CONSTRUCTION BID ADDENDUM NO. 2

TO: ALL BIDDERS		DATE ISSUED 2/27/2025
PROJECT NAME Cadillac Place – UIA Lobby Redesign		FILE NUMBER 186/23271.MNB
PROFESSIONAL DS Architects, Inc.	PROJECT DIRECTOR Chris Bahjet	BID OPENING DATE: 3/5/2025

PROJECT DESCRIPTION
**CADILLAC PLACE - UJA LOBBY
 REDESIGN**

A-101.0

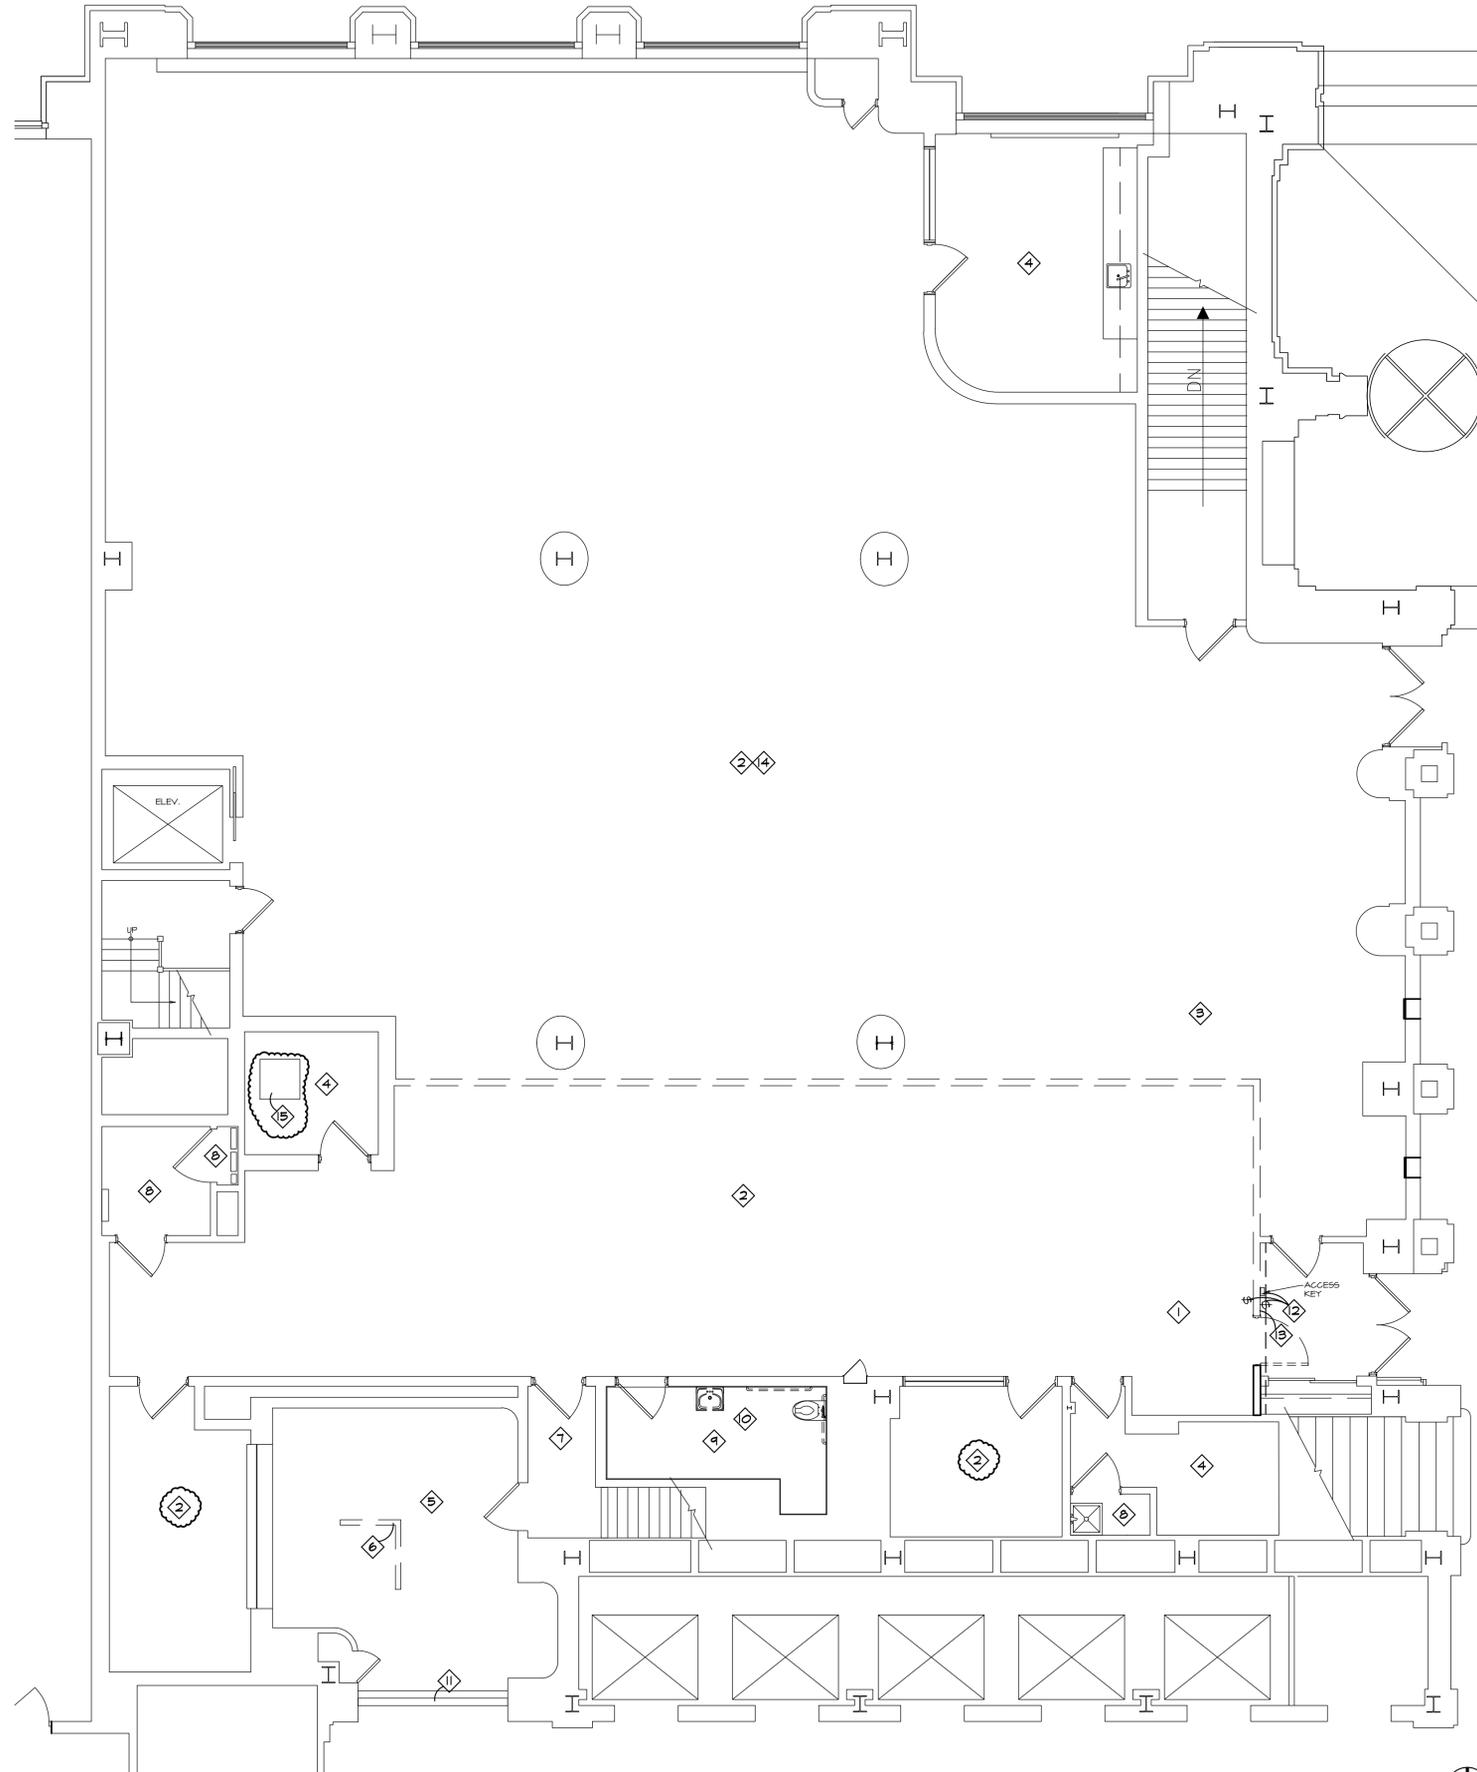
1. Sheet A-101.0: Modified notes #4, #5, #8, #14 and added note #15.
2. Sheet A-101.1: Modified note #10.
3. Sheet A-101.3: Modified finishes in Elec. Clos. #109, Elec. #110, Stor. #112, and Jan. Clos. #113.
4. Sheet A-201: Added detail #4.

4 TYPICAL ADA RESTROOM SIGNAGE
 A-101.1 6" = 1'-0"

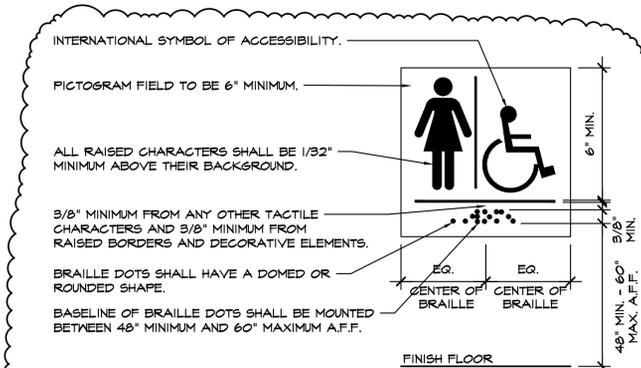
1. “You have a spec for room identification panel signage which is keynote 10 looks like only one is shown for the bathroom. Can you provide a detail for the sign so we can price accordingly.”

Answer: Please see detail #4 on sheet A-201 in addendum #1 drawings and specification section 101423.16 in the bid specs.
